### APPEAL SUMMARY

<b>Appeal ID:</b> 20263	<b>Project Address:</b> 1715 SW Salmon St
<b>Hearing Date:</b> 4/17/19	<b>Appellant Name:</b> John Smith
<b>Case No.:</b> B-012	<b>Appellant Phone:</b> 503.445.7350
<b>Appeal Type:</b> Building	<b>Plans Examiner/Inspector:</b> Brian McCall, Joe Thornton
<b>Project Type:</b> commercial	<b>Stories:</b> 8 <b>Occupancy:</b> R-2, A,B,S <b>Construction Type:</b> I-A, III-A
<b>Building/Business Name:</b> 18S	<b>Fire Sprinklers:</b> Yes - Full NFPA 13
<b>Appeal Involves:</b> Erection of a new structure	<b>LUR or Permit Application No.:</b> 19-106743-CO
<b>Plan Submitted Option:</b> pdf [File 1]	<b>Proposed use:</b> mixed use housing

<b>Code Section</b>	202, High-Rise Building Measurement
<b>Requires</b>	Section 202 defines a high-rise building as "a building with an occupied floor located more than 75 feet about the lowest level of fire department vehicle access".
<b>Proposed Design</b>	<p>The project is being developed in concert with TriMet and the City of Portland to create a transit-oriented development at this long-underutilized site in Goose Hollow. The site is adjacent to the Kings Hill Max Station, along SW Salmon Street between SW 17th

1 ENLARGED TERRACE PLAN

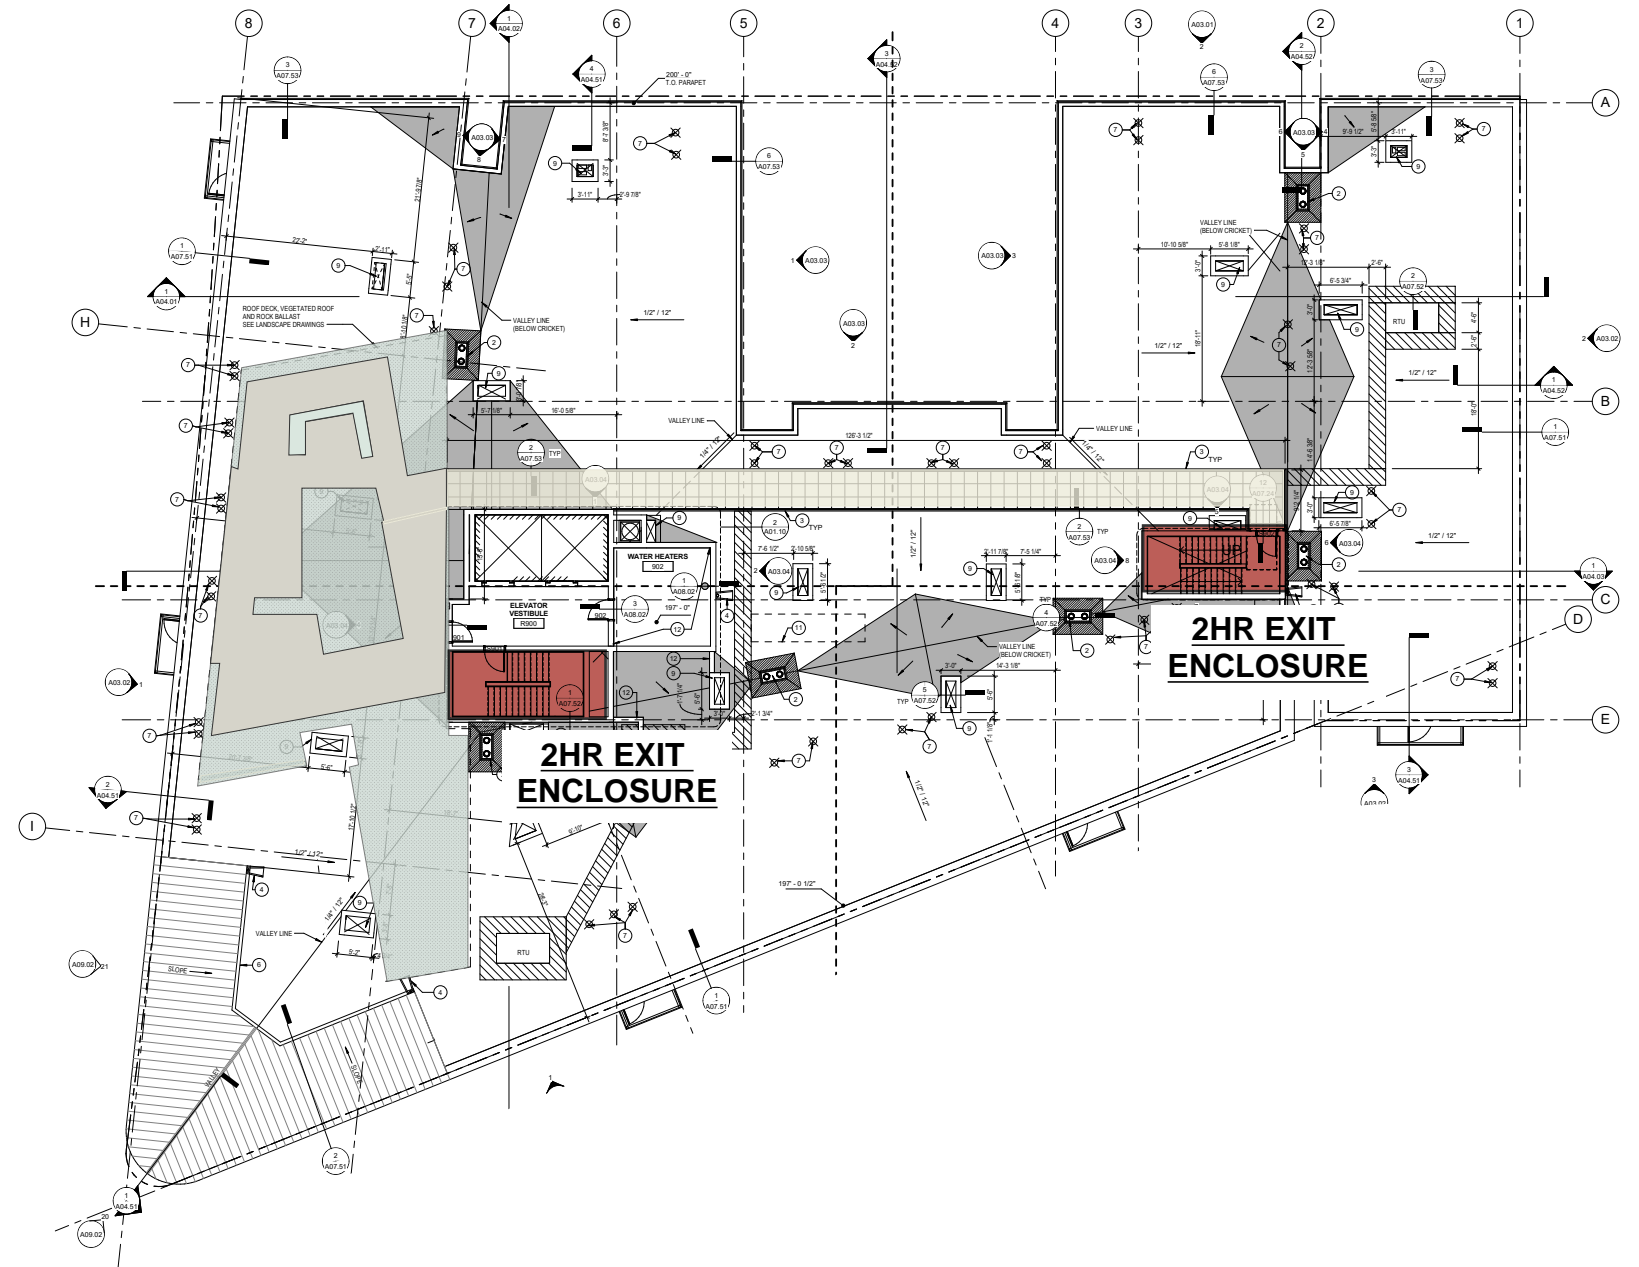
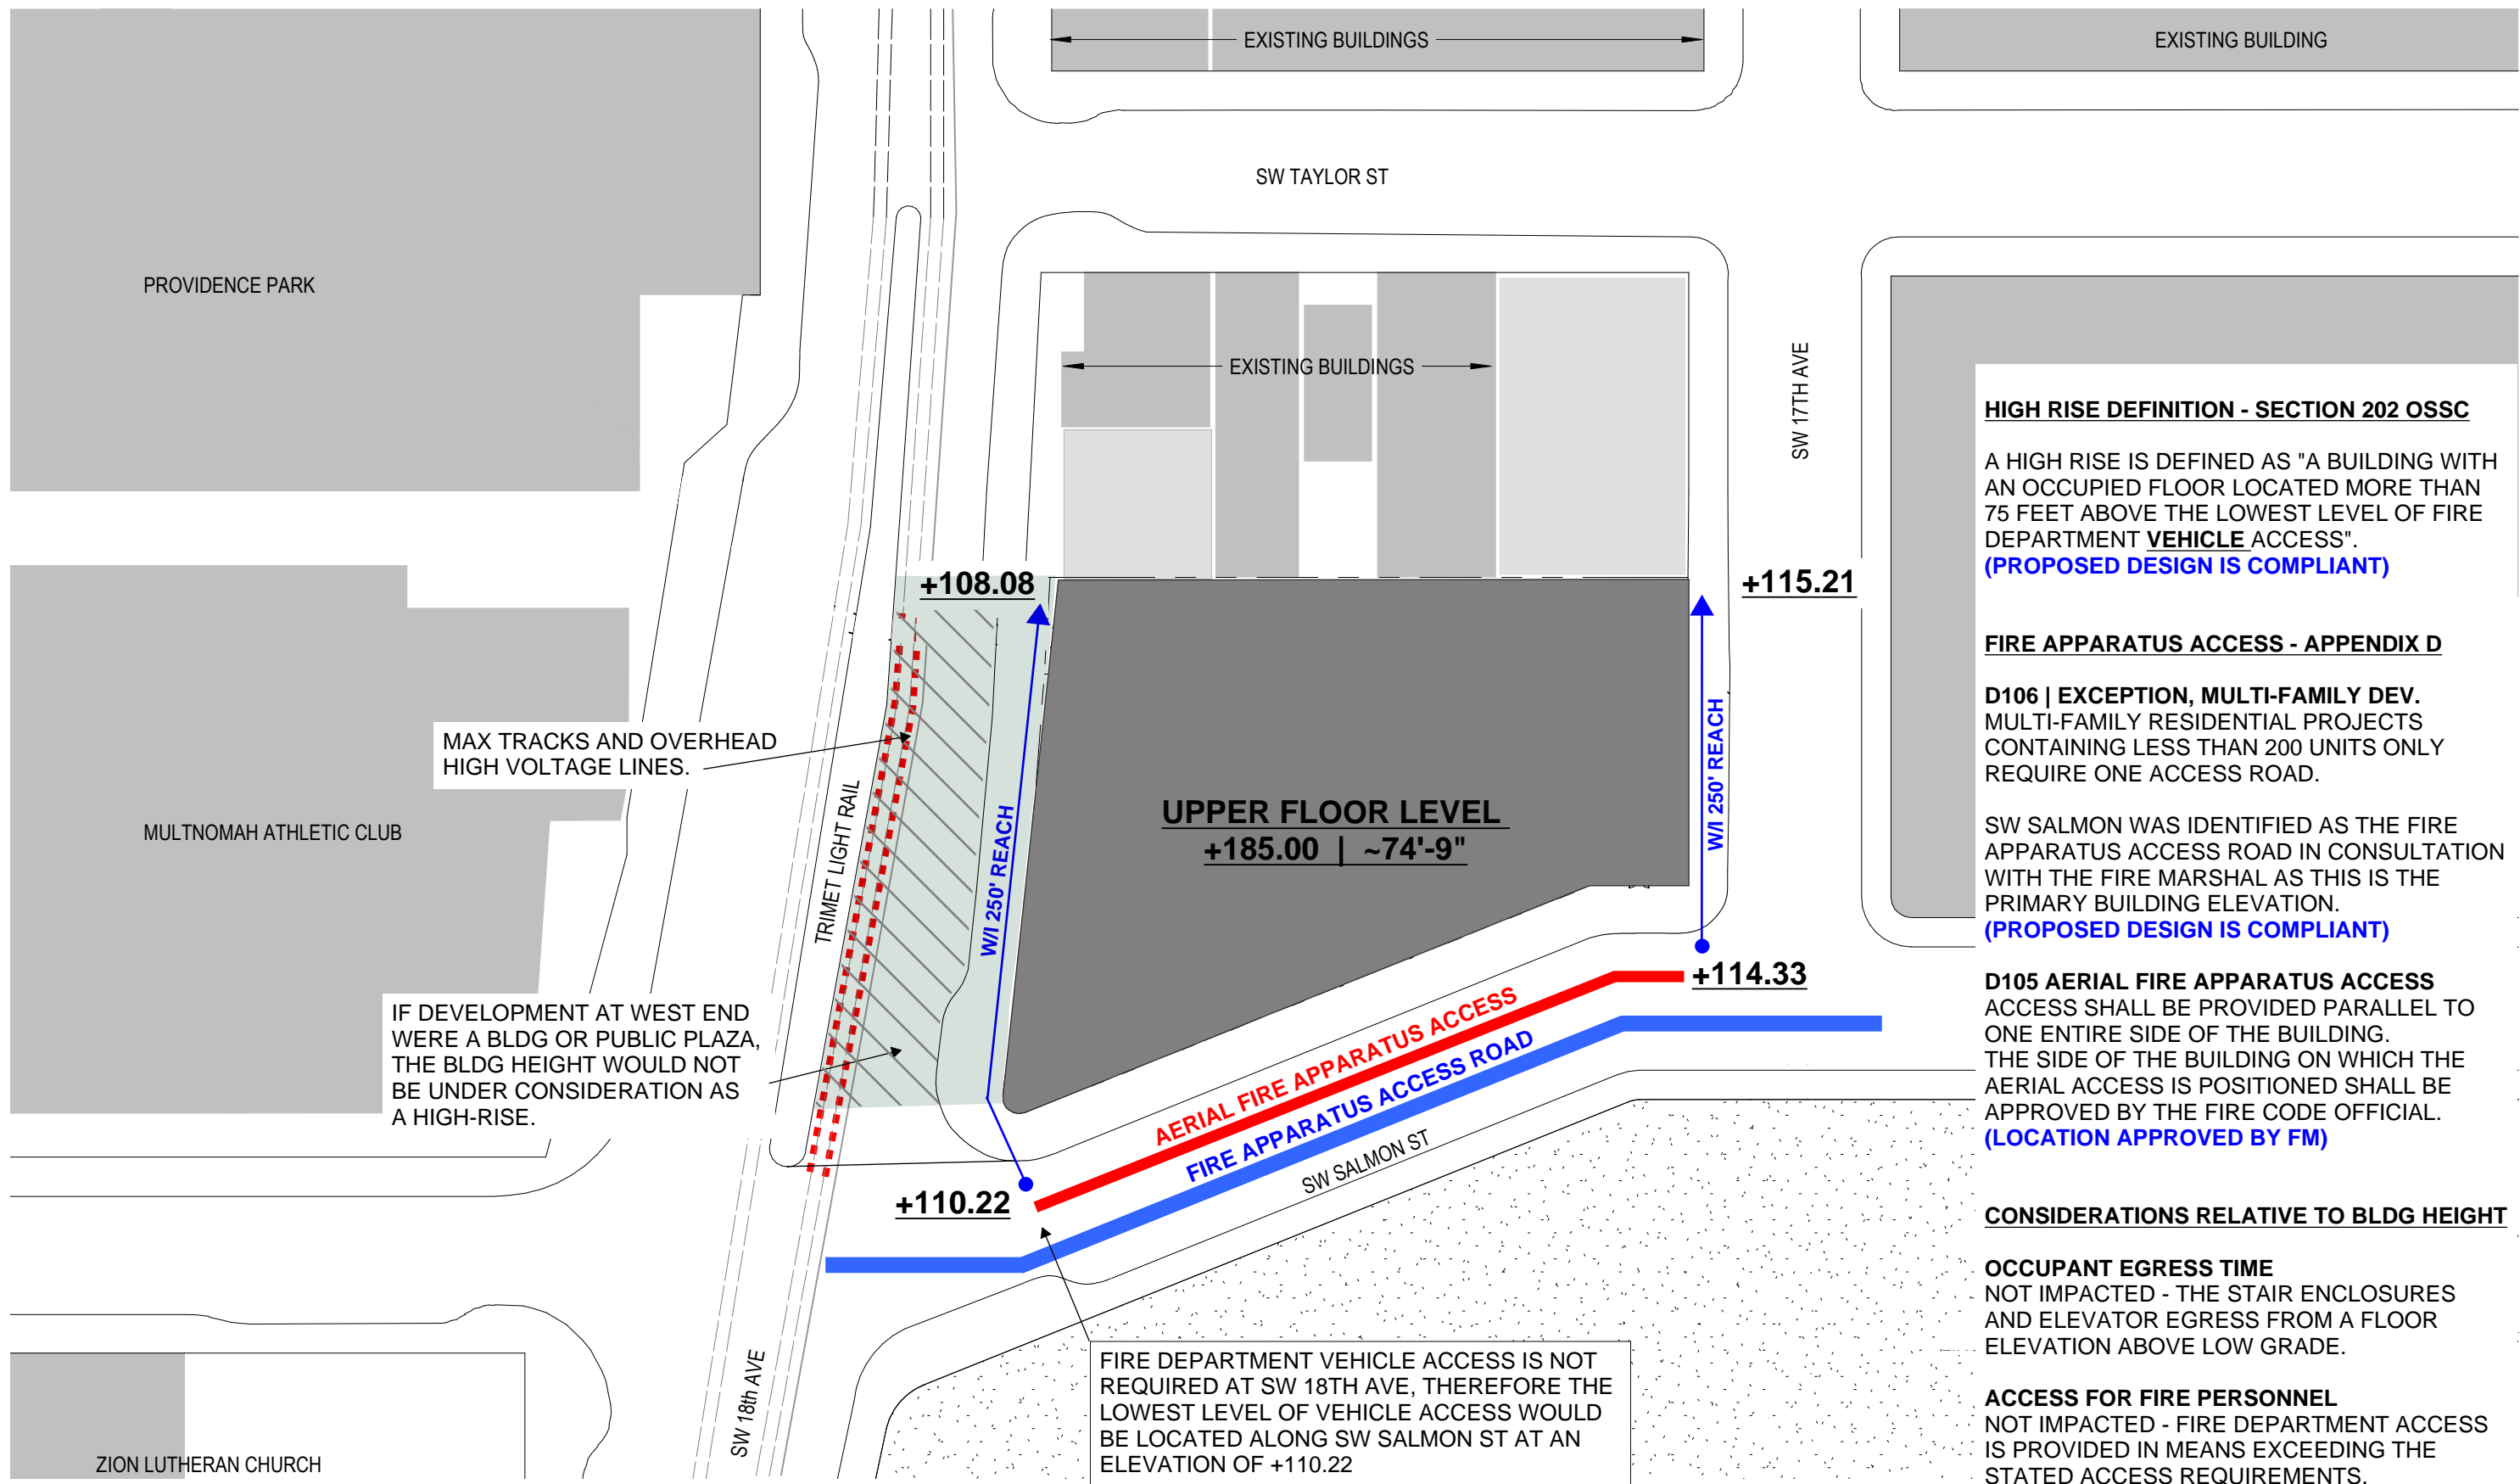
**2. Roof deck located above maximum number of stories: Granted as proposed per ICC approved 2018 IBC model code change lifting restriction on location of roof decks in a fully sprinkled building and with occupant notification in the area of the occupied roof. Elements or structures enclosing the occupied roof areas shall not extend more than 48" inches above the surface of the occupied roof. Fire Marshal's office may revoke if found to be in violation of this appeal.**

**+110.22'**  
**LOWEST GRADE OF FIRE  
DEPARTMENT VEHICLE ACCESS**

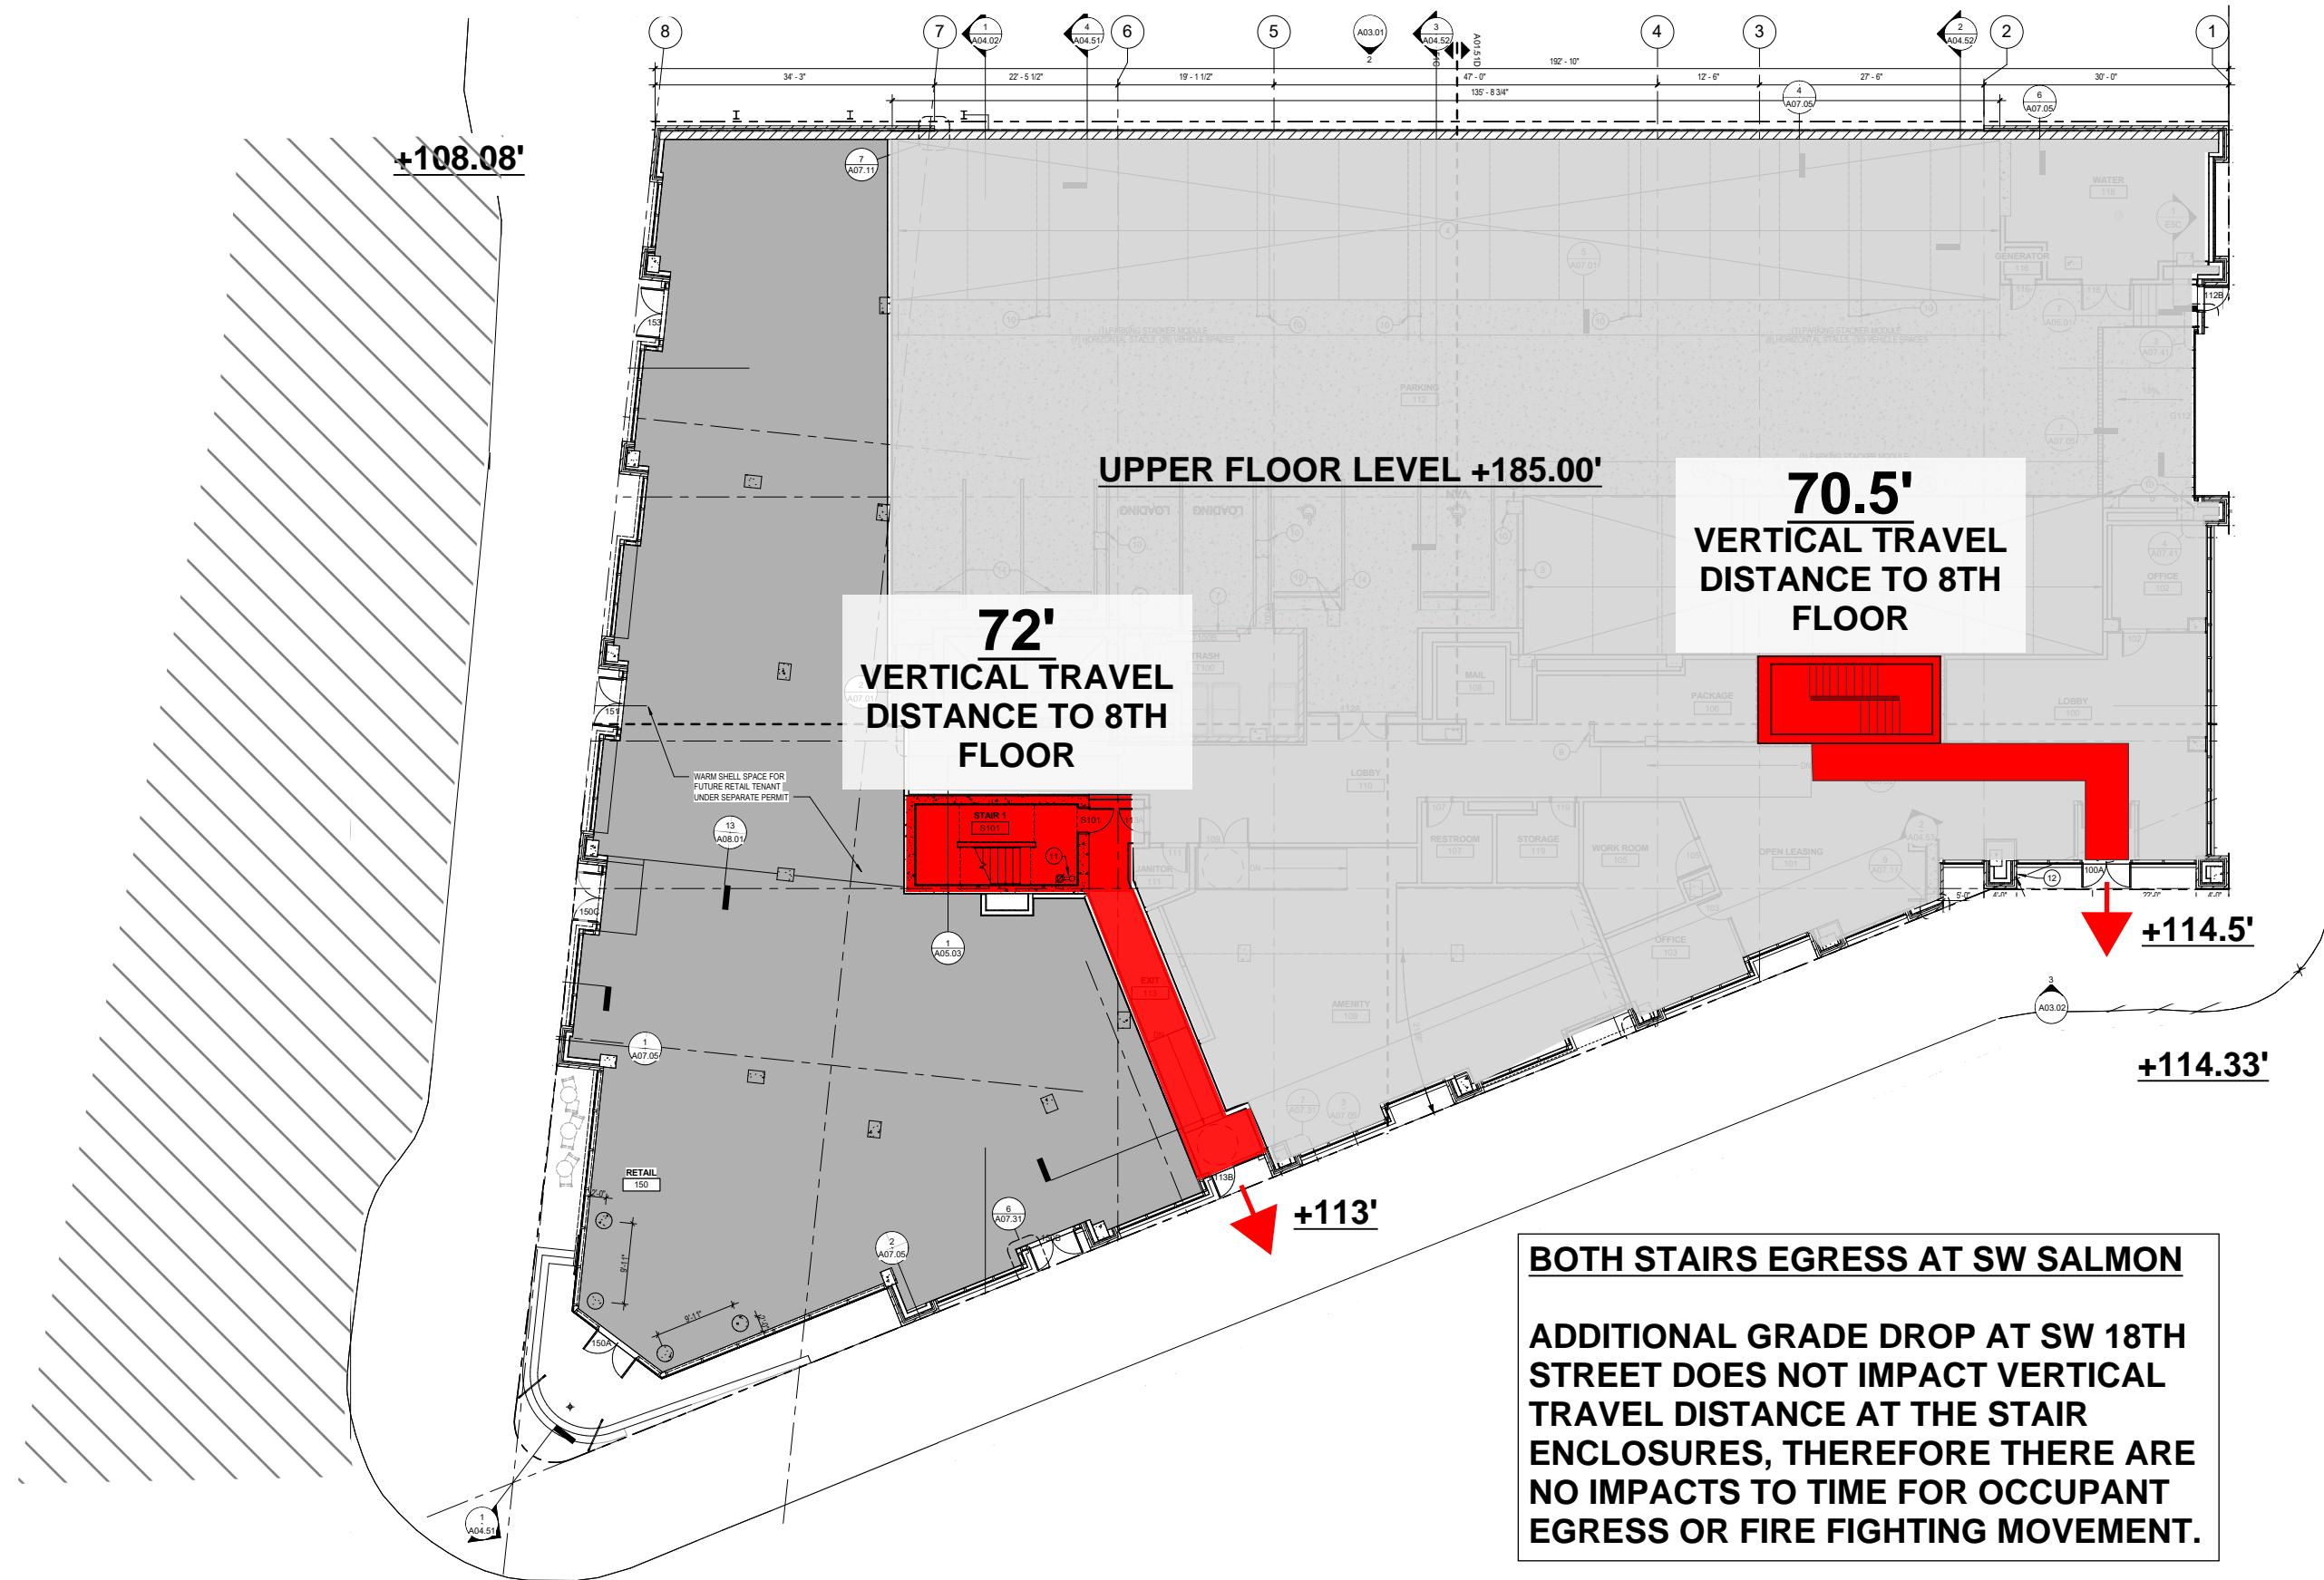
**1. Determination of the lowest point for calculating the lowest level of fire department vehicle access: Denied. Proposal does not provide equivalent Life Safety protection.**
